AMENDMENTS TO THE DRAWINGS

REMARKS

Application No. 10/713,437
Amendment Dated November 11, 2005
Reply to Office Action of September 1, 2005
Annotated Sheet Showing Changes

FIG. 1

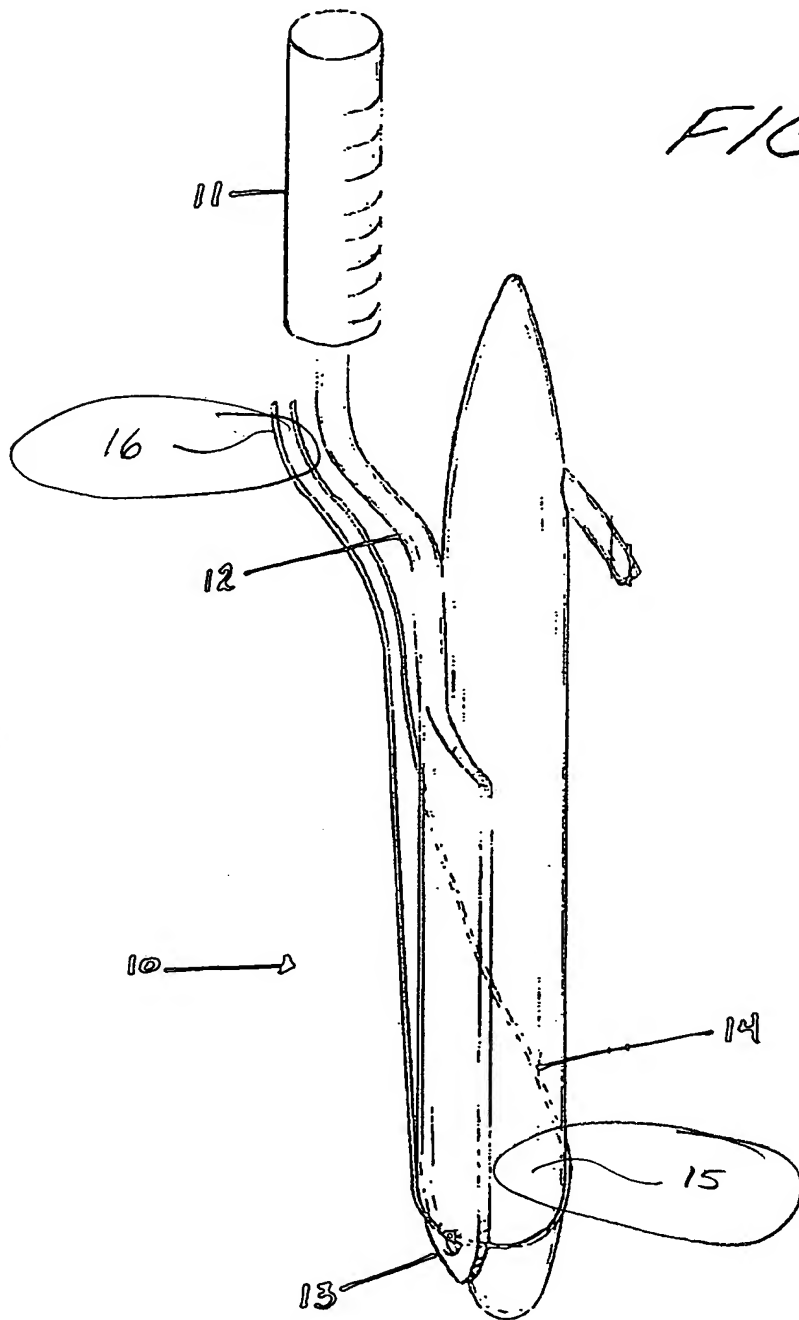
Fig. 1 has been amended to include additional item numbers that correspond with the description amended in the specification. Specifically, item numbers 15 and 16 have been added to Fig. 1, wherein item number 15 is the outwardly angled shaft section and item number 16 is the linear handle section.

Applicant has amended Fig. 1 to include additional item numbers that correspond with the description amended in the specification. Specifically, item numbers 15 and 16 have been added, wherein item number 15 is the outwardly angled shaft section and item number 16 is the linear handle section.
